STATE OF NORTH CAROLINA
DEPARTMENT OF TRANSPORTATION

February 10, 2015

Subject: **Application Modification Request for USACE Individual Permit, Section 401 Water Quality Certification, Neuse Riparian Buffer Authorization and CAMA Major Development Permit** for the proposed improvement of US 17 from south of Belgrade at SR 1330/SR 1439 to the New Bern Bypass, in Onslow, Jones and Craven Counties. TIP No. R-2514 B, C & D.

Utility Permit Drawing
Sheet 2 of 20
Revised 1/30/15

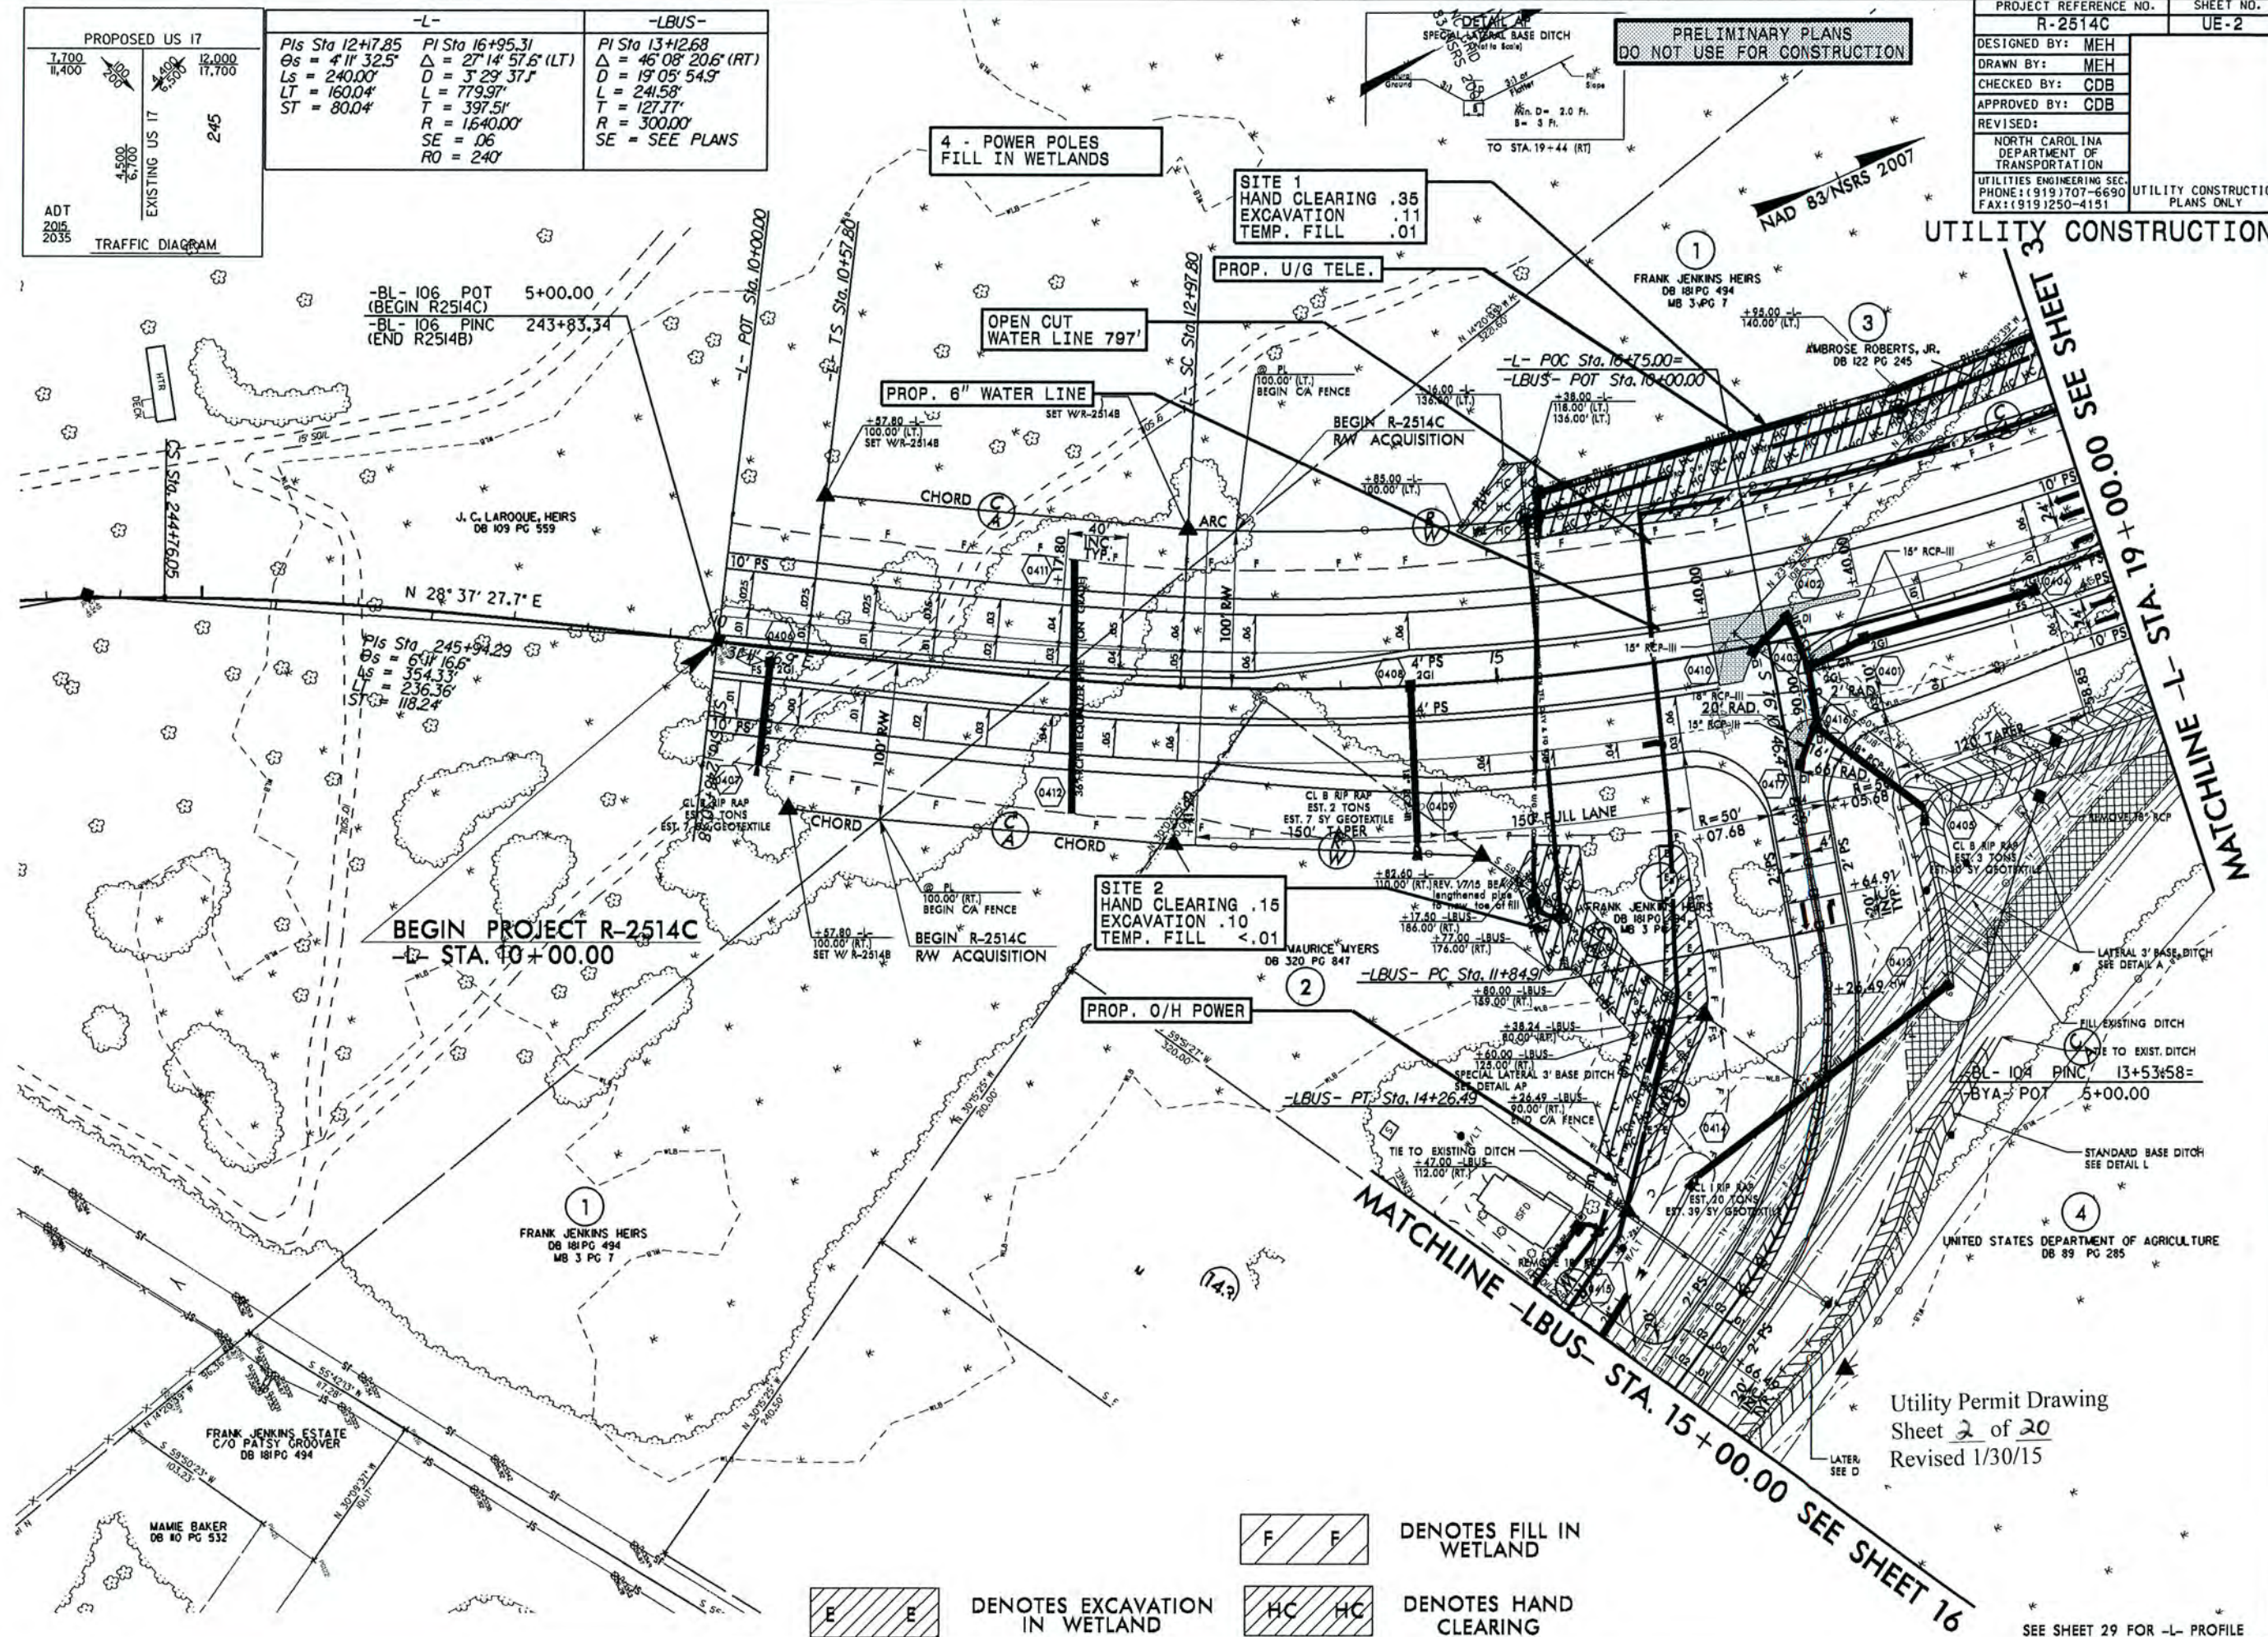
Comment 4: *Section C – There are two sets of impacts for power lines; one has impact sites 1-5 and the other has impacts sites 1-27. Please resolve this discrepancy.*

Response: The permit drawings depicting utility impacts for section C have been consolidated into a single set of drawings depicting all sites. The new drawings are attached.

Utility Permit Drawing
 Sheet 3 of 3
 Revised 1/23/15

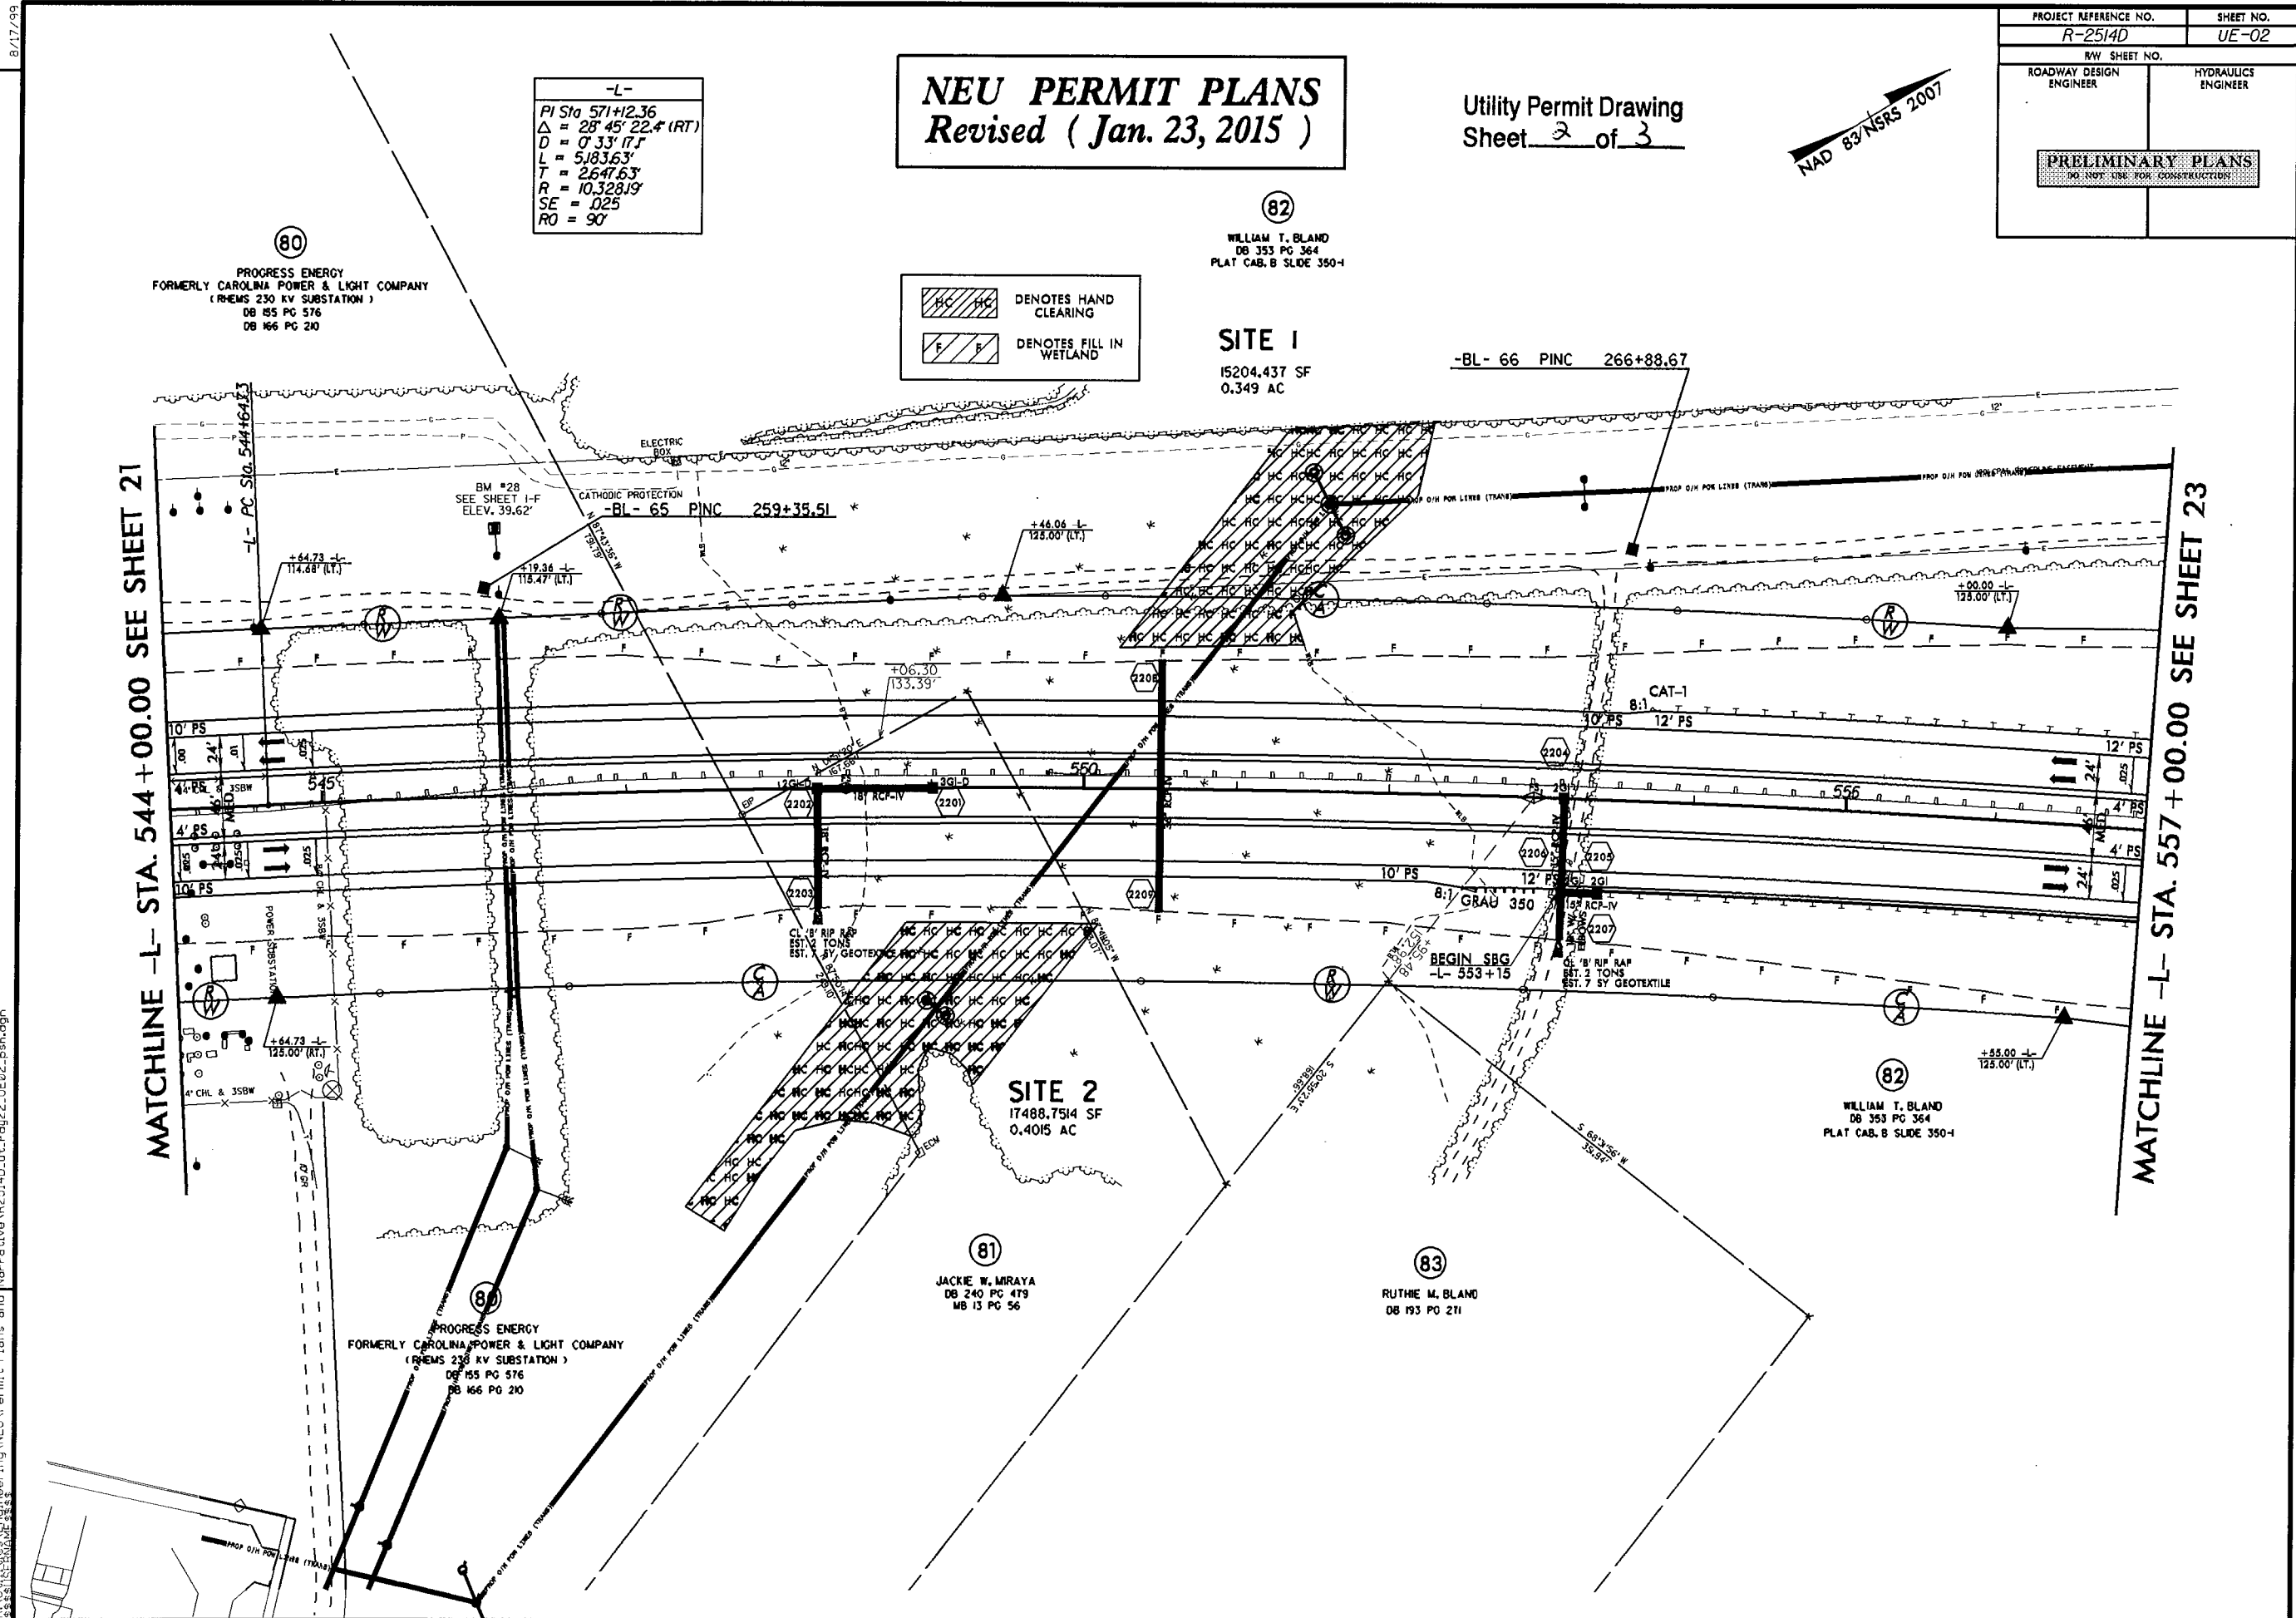
Comments 5 and 6: *Section D – At Utility Site 1 there appear to be power pole/line relocations.*

The amount of hand clearing requested seems to be excessive for the proposed activity. Please explain why this amount of clearing is necessary. At Utility Site 2 the amount of hand clearing requested seems excessive for the proposed utility relocation. Please explain why this amount of clearing is necessary.

Further coordination with the utility companies has reduced the clearing impacts in this area of the project. However, this review revealed an error in the permit application at these impact sites. Specifically, the summary sheet incorrectly lists the impacts at Site 1 and 2 as 0.01 and 0.60 acres respectively, and showed the total impacts as 0.61 acres in the permit application. Utility Permit Drawings Sheet 2 correctly showed that Site 1 impacted 1.259533 acres and Site 2 0.5993 acre, a total of 1.86 acres. The Utility Permit Drawing data was incorrectly transferred to the summary sheet.

The revised drawings included in this submittal show a much reduced footprint; with Sites 1 and 2 impacting 0.35 and 0.40 acre due to hand clearing. This reduced the impacts from 1.86 acres to 0.75 acre.
